DOCKETED	
Docket Number:	26-TIRE-01
Project Title:	Tire Efficiency Rulemaking
TN #:	271628
Document Title:	Gladfelty Government Relations Comments - GGR Letter on Replacement Tire Efficiency Program Revised Proposed Regulations
Description:	N/A
Filer:	System
Organization:	Gladfelty Government Relations
Submitter Role:	Public
Submission Date:	7/27/2026 11:45:53 AM
Docketed Date:	7/27/2026

**GGR Letter on Replacement Tire Efficiency Program Revised
Proposed Regulations**

Re: Replacement Tire Efficiency Program – Revised Proposed Regulations Still Leave Phase 2 Consumer Cost Assumptions Unresolved (TN 271526)

Smithers Phase 2, Chart 5.5A-style overlay: Base Tire subset only, with lower-load-index and higher-speed-index tires removed because they are subject to different Phase 2 limits.

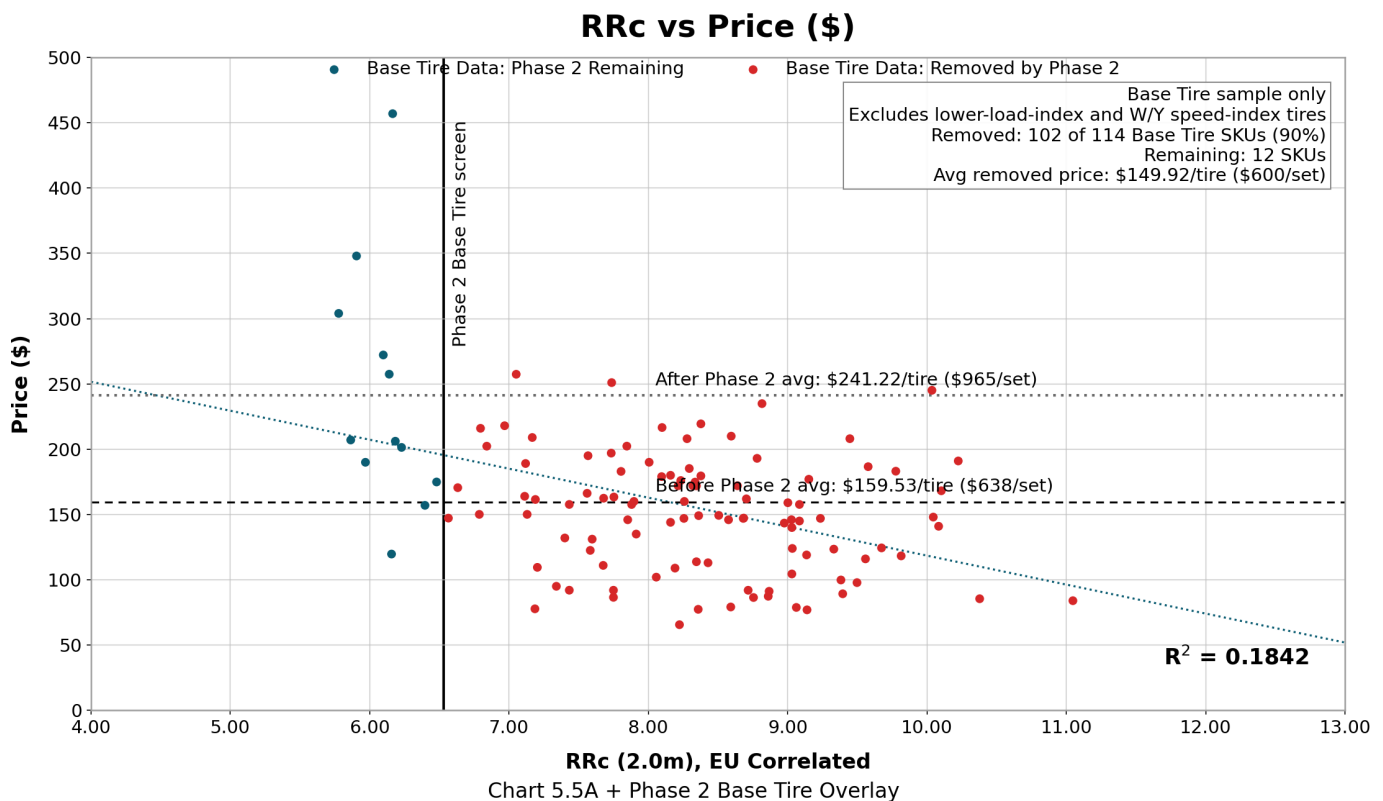
The relevant record is Smithers' Phase 2 report, not an industry model. Smithers states that tire price is the "actual price paid per tire, excluding sales tax and shipping," and that the tire SKUs were chosen by CEC. Smithers then conducts a "Rolling Resistance vs Price" analysis using passenger tire SKUs from Phases 1 and 2, adjusted per EU correlation. On page 28, Smithers states the trendline exhibited "a negative slope, with increasing price for lower rolling resistance." Chart 5.5A on page 29 illustrates the same point: if the proposed Phase 2 default threshold of 7.1 RRC is applied as a reference point, the

lower-RRC side of the chart includes tires near \$200, \$300, and above \$450 per tire, while many higher-RRC tires remain clustered around roughly \$50 to \$150 per tire. That is not a marginal \$6.50-per-tire issue. It is a potential several-hundred-dollar point-of-sale issue for a set of four tires. (Smithers Phase 2, TN 269613, pp. 7-8, 28-29.)

Cost Comparison with 95% Confidence Intervals

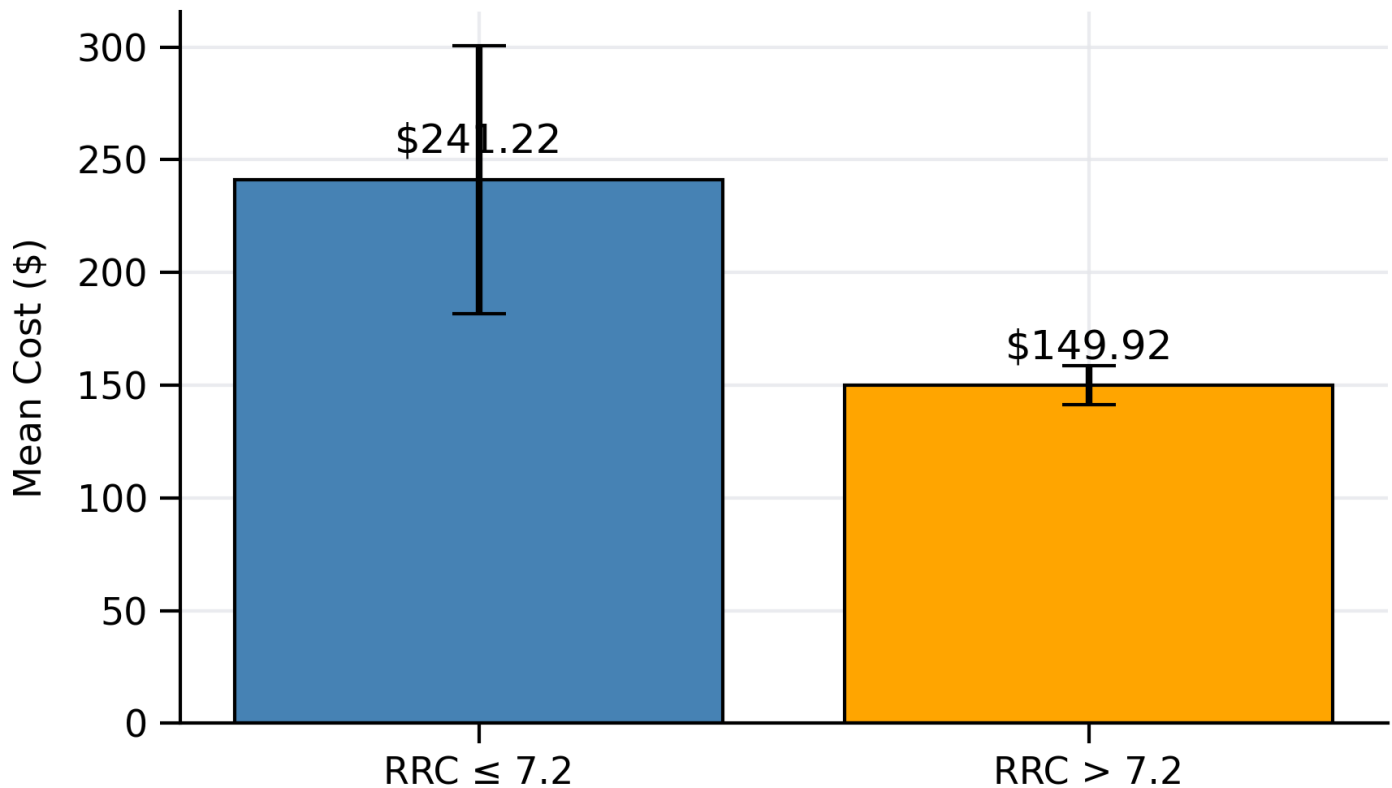
The market impact is not theoretical. Applying the Phase 2 7.1 RCC limit to the Smithers passenger-car-tire (PCT) population shown above would remove 102 of 114 PCT SKUs (90%) and raise the average price of the remaining compliant tires from \$149.92 per tire (\$599.68 per set) to \$241.22 per tire (\$964.88 per set). Discount Tire/America's Tire, which operates 151 stores in California, separately warned that if Phase 2 were applied to the tires it sells in California today, roughly 70 percent of currently available options would be removed from the market. That is the practical consumer-cost question.

Please see the chart below comparing Base Tire prices above and equal to below the RRC Phase 2 limit of 7.1 from the Smithers CEC dataset, which includes tire prices. There is a statistically significant increase of \$ 365.20 / set of tires for lower RRC tires from the CEC's data, which is far greater than the CEC's estimated increase of \$26 / set of tires. Using CEC's estimated \$179 fuel savings over the life of a set of tires, this regulation will cost consumers \$186.20.

At minimum, CEC should revise the cost analysis before final adoption to include actual SKU-level price comparisons from the Smithers data; fitment-by-fitment replacement options that would remain available under Phase 2; sales tax, installation, disposal fees, redesign costs, compliance testing, and retailer availability impacts; and a market availability trigger requiring CEC to adjust or delay standards if consumer prices rise materially or available SKUs fall below a reasonable threshold.
